ADDENDUM No. 1
for
INDIANA STATE FAIR COMMISSION
DISCOVERY HALL TENANT
IMPROVEMENTS
1202 East 38th Street
Indianapolis, Indiana 46205

July 8, 2011

ADDENDUM NO. 1

SKETCH NUMBER C-1

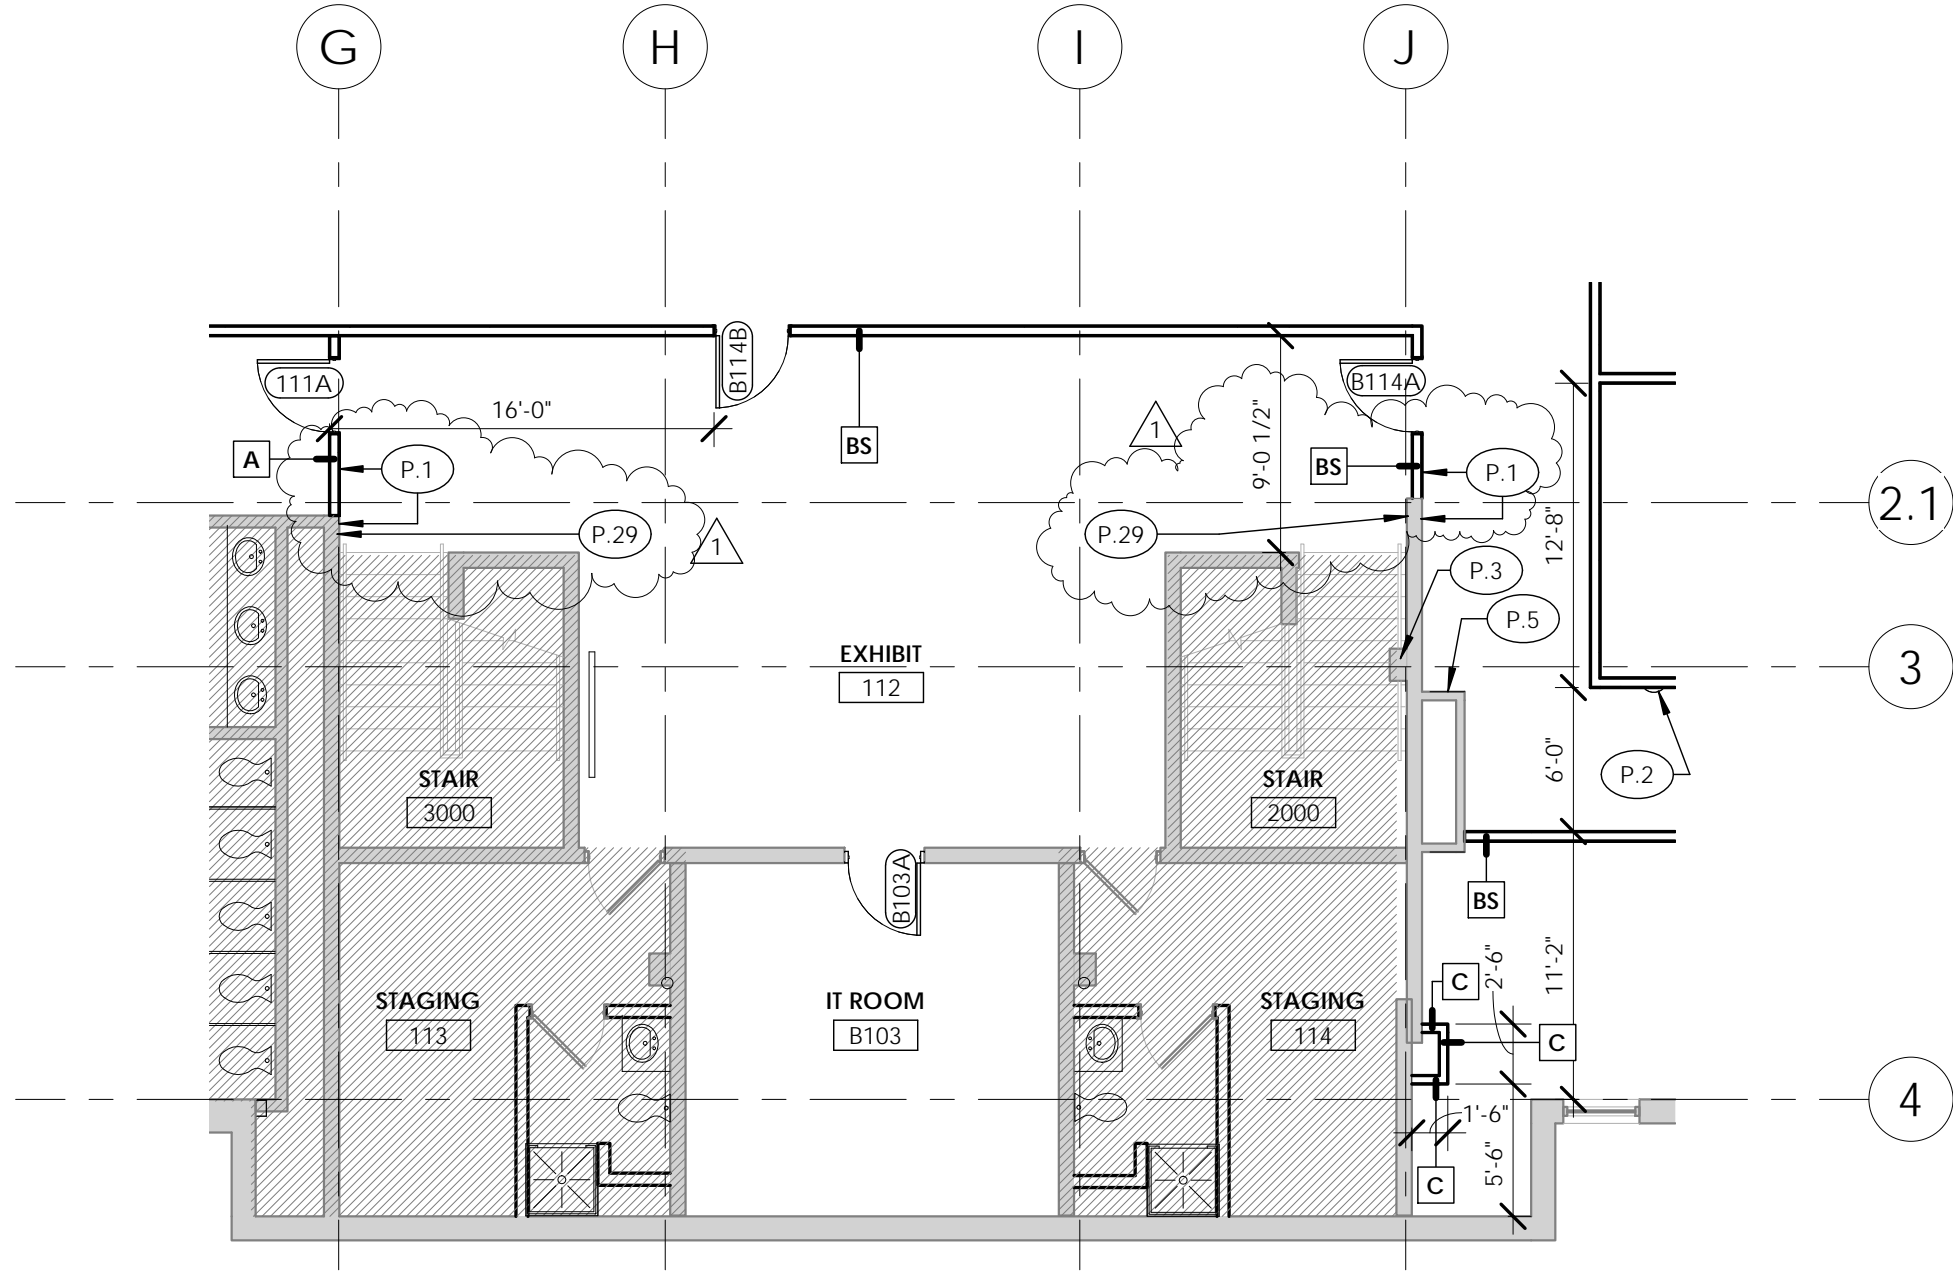
1. Revise Drawing C202 as revised by Sketch C-1.
2. Concrete walks do not require any reinforcing.

ADD.1-1

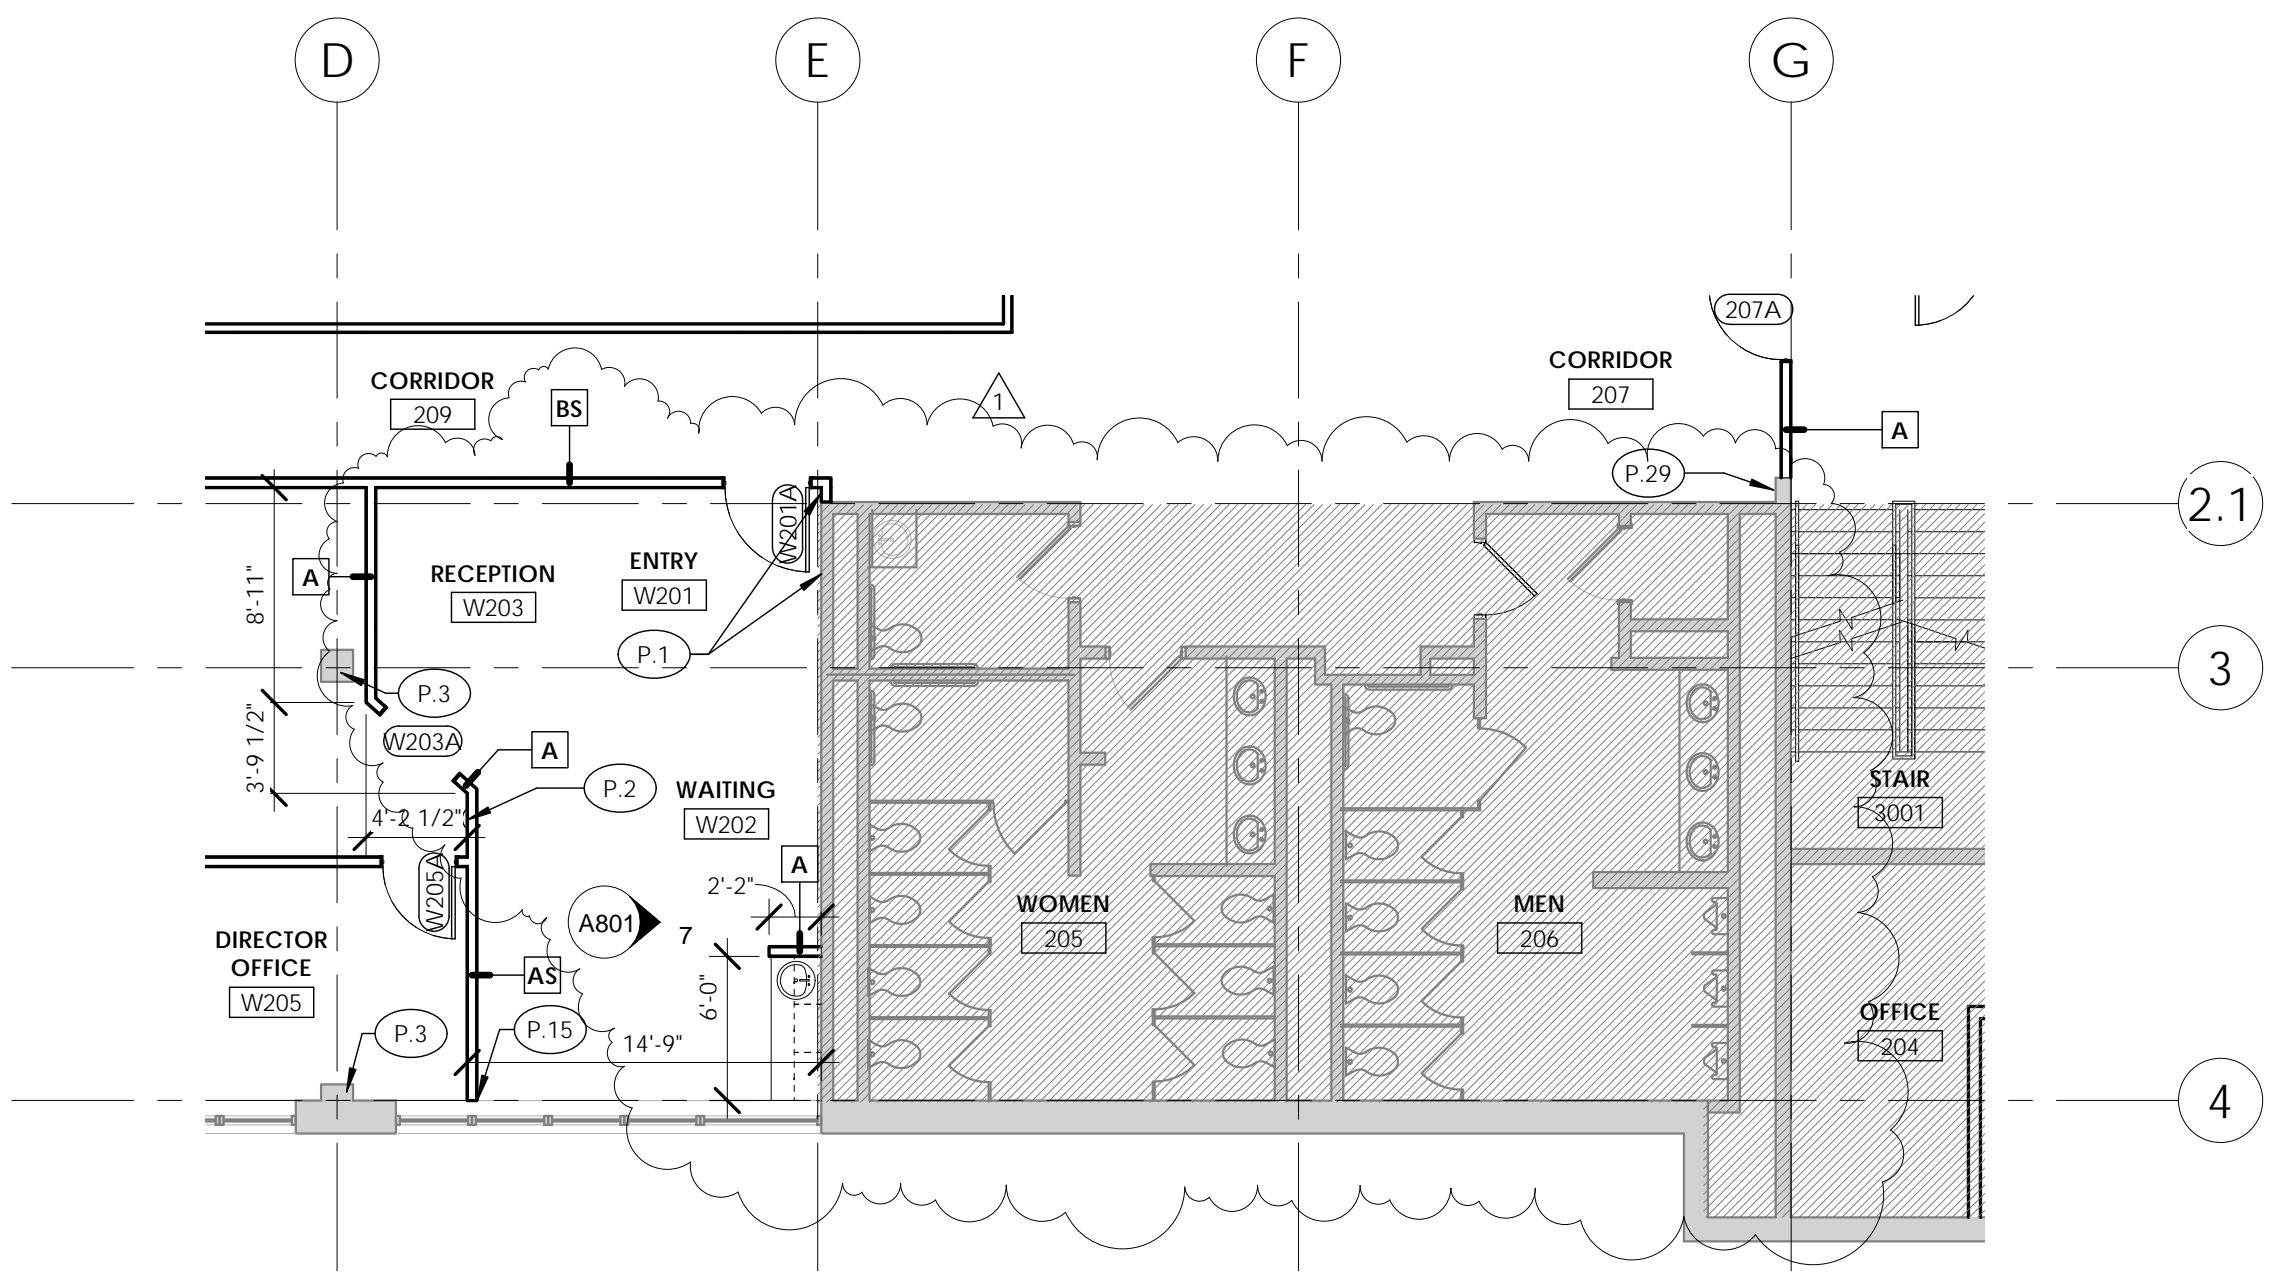
1. Add Plan Note to the Architectural Key Notes: P.29 PATCH BRICK AS REQUIRED TO MATCH ADJACENT EXISTING MASONRY FINISH. PROVIDE ALUMINUM WALL CAP TO COVER (+/- 6" in width, V.I.F) AND SEAL EXPOSED EDGES (SIMILAR TO PREVIOUS CONSTRUCTION PHASE).
2. Revise Drawing A101: Add Plan Note P.29 to wing wall locations at Exhibit 112. See Sketch ADD.1-1.

SHEET
ADD.1-3

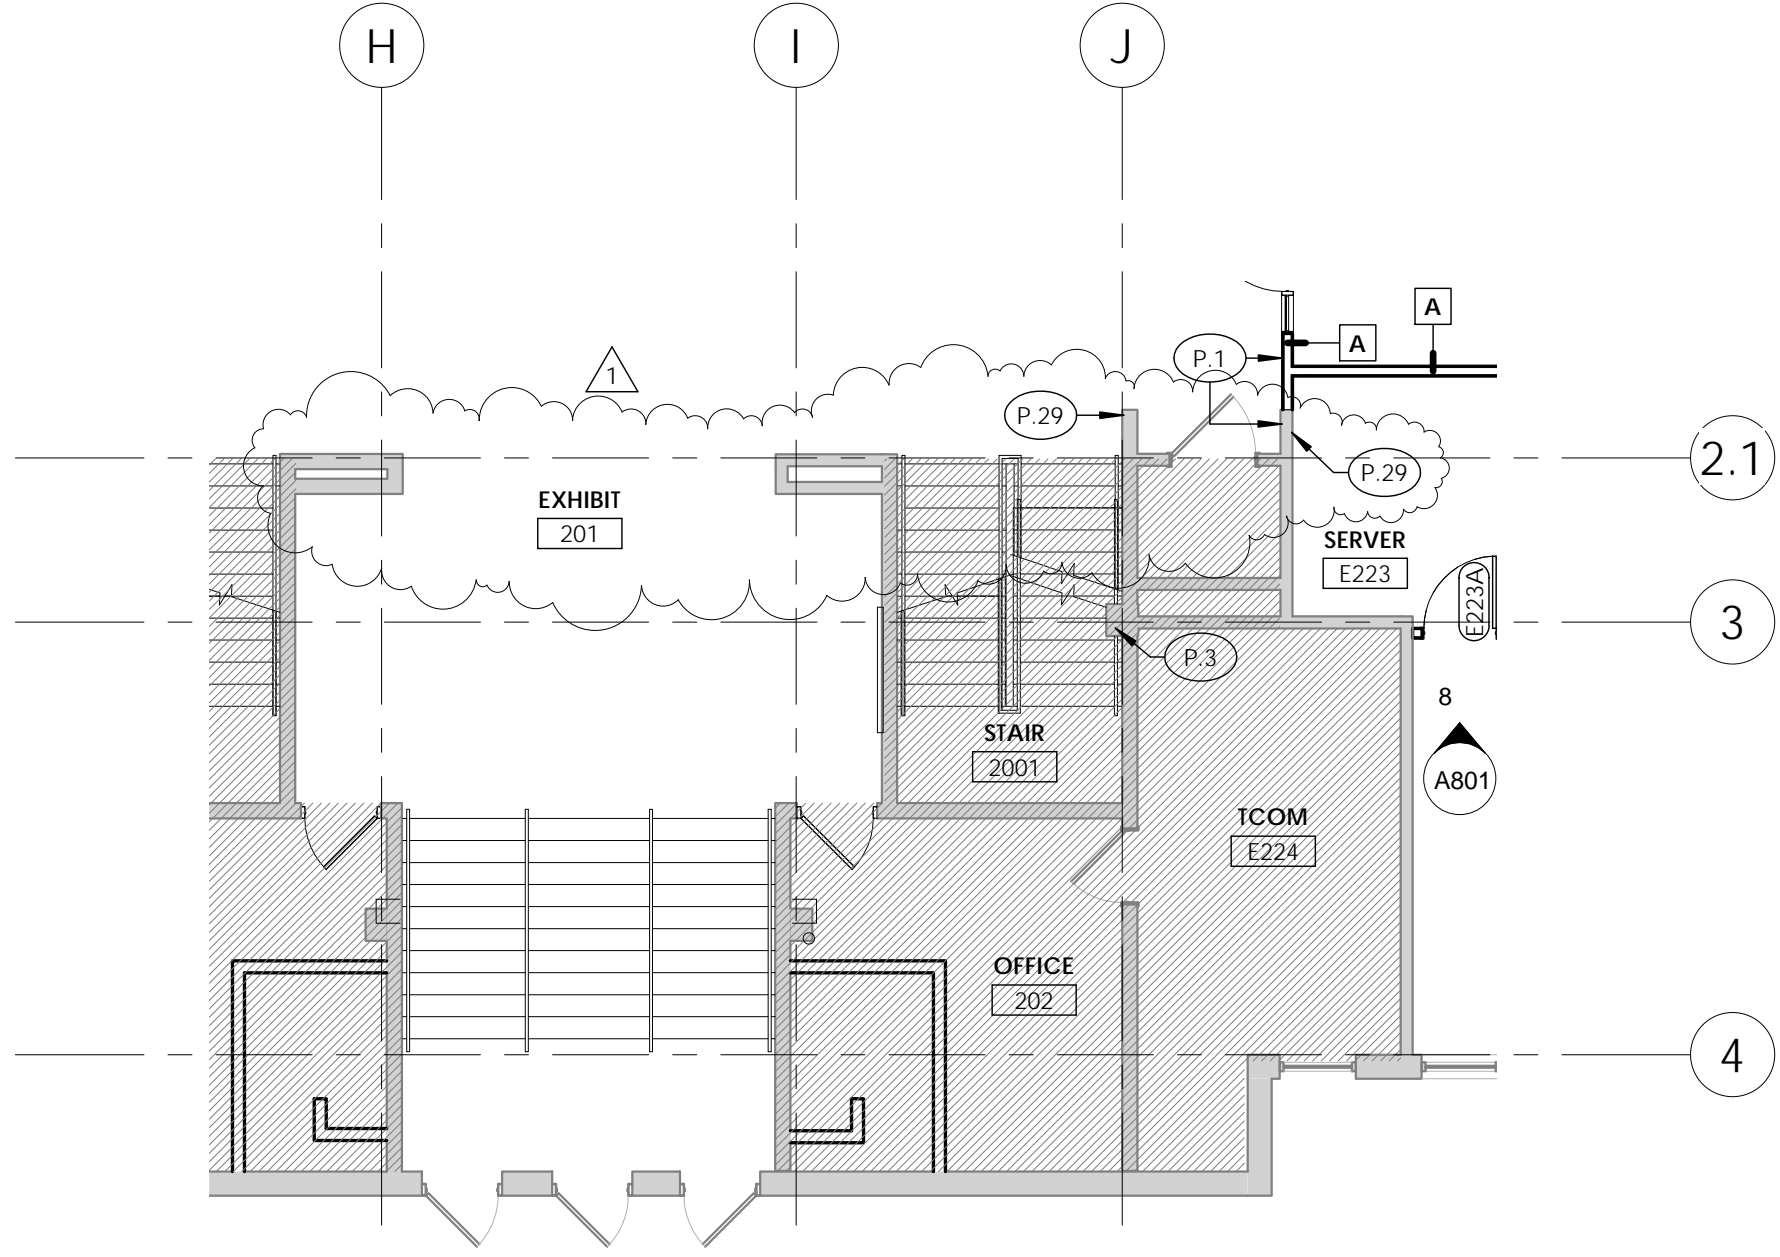
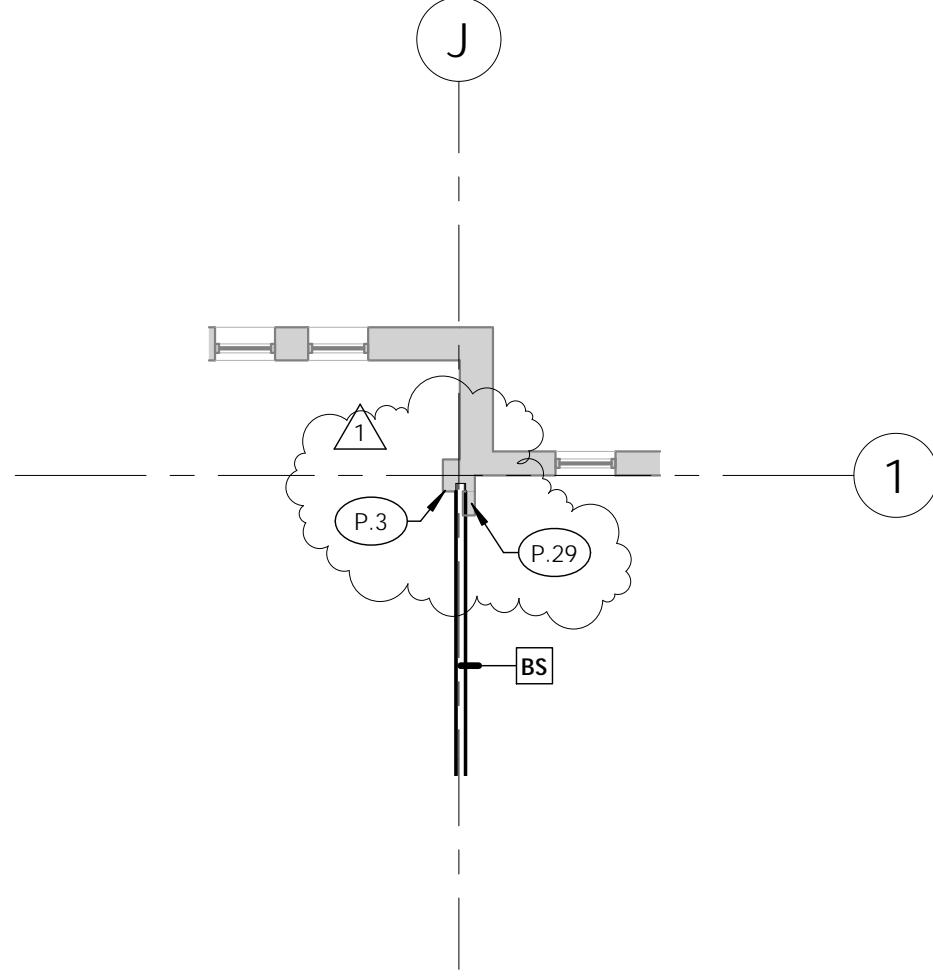
1. Revise Drawing A102 as indicated on Sketches ADD.1-2, ADD.1-3, ADD.1-4, ADD.1-5.
2. Room W203 indicates movable furniture provided by Owner. This is NOT casework at this location.
3. Detail 2/A102 shows a Steel Channel Column Repair. This is an EXISTING condition.
4. Patch, repair, and paint, as necessary, brick near Stair 4001 (located in Corridor 211).

ADD.1-5

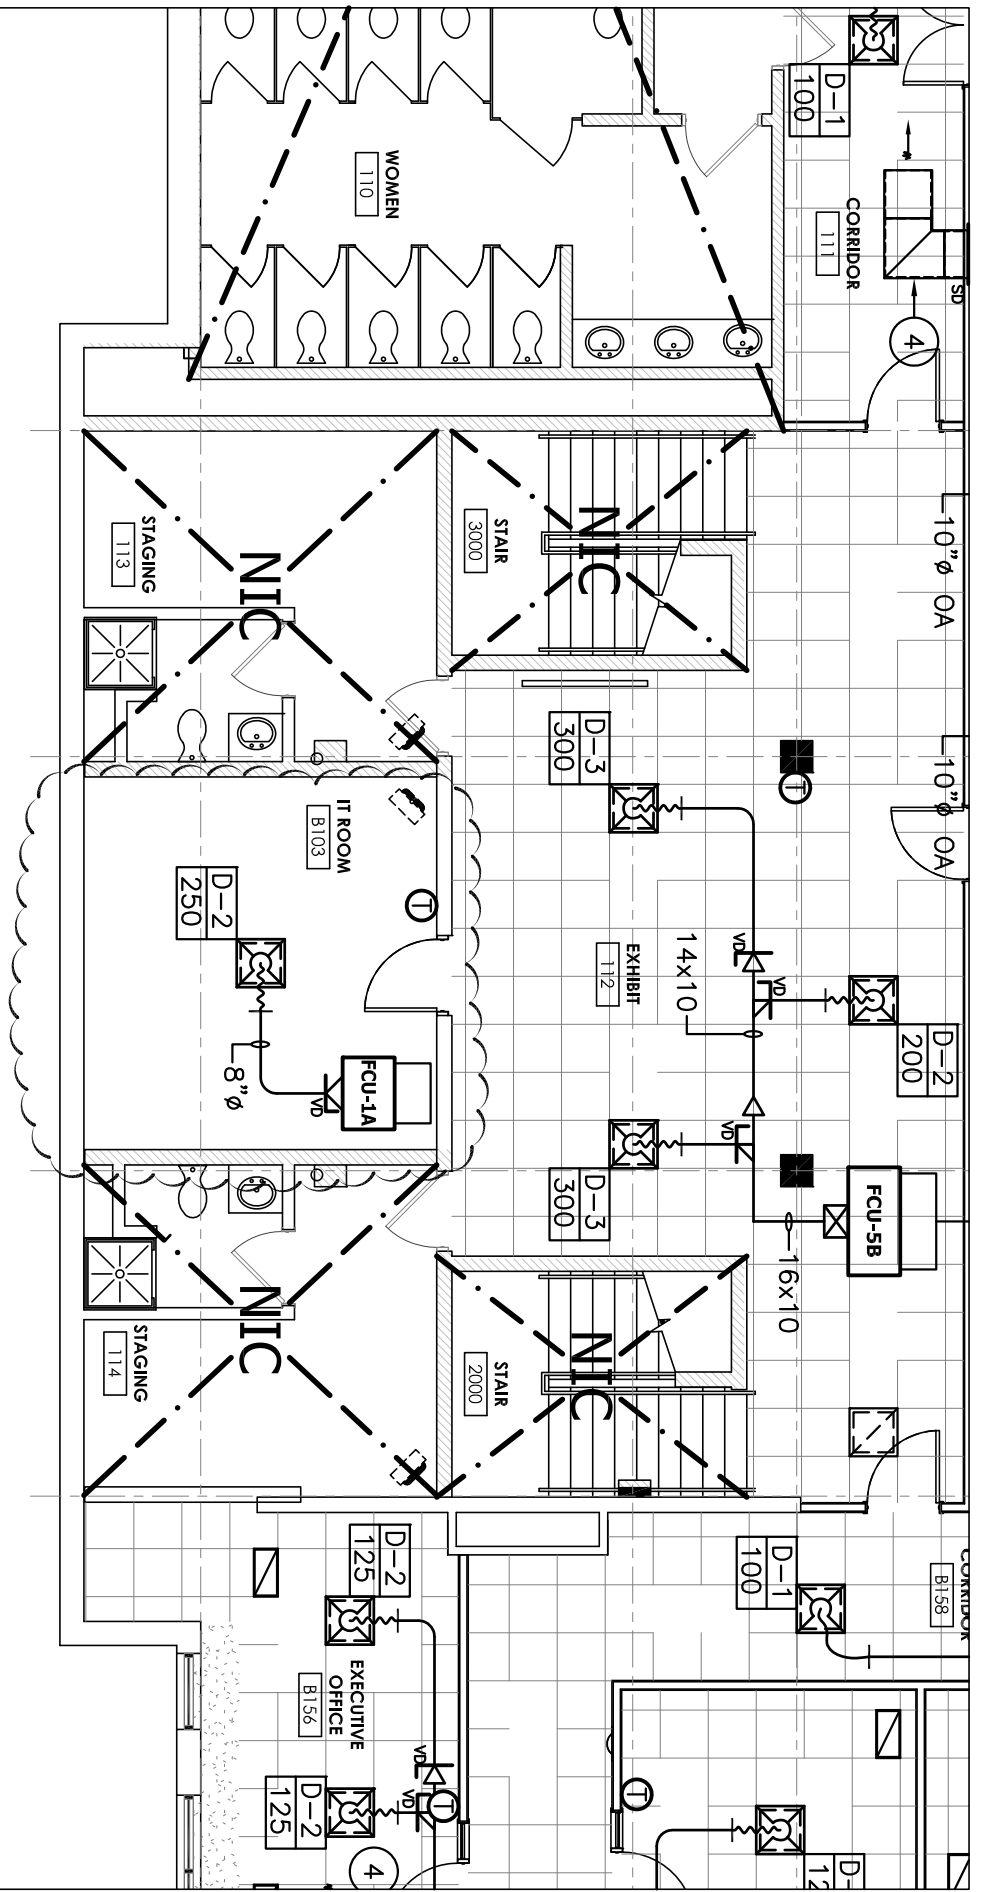
9. Copy/Production E212, see 8 ½ x 11 drawing in this addendum.
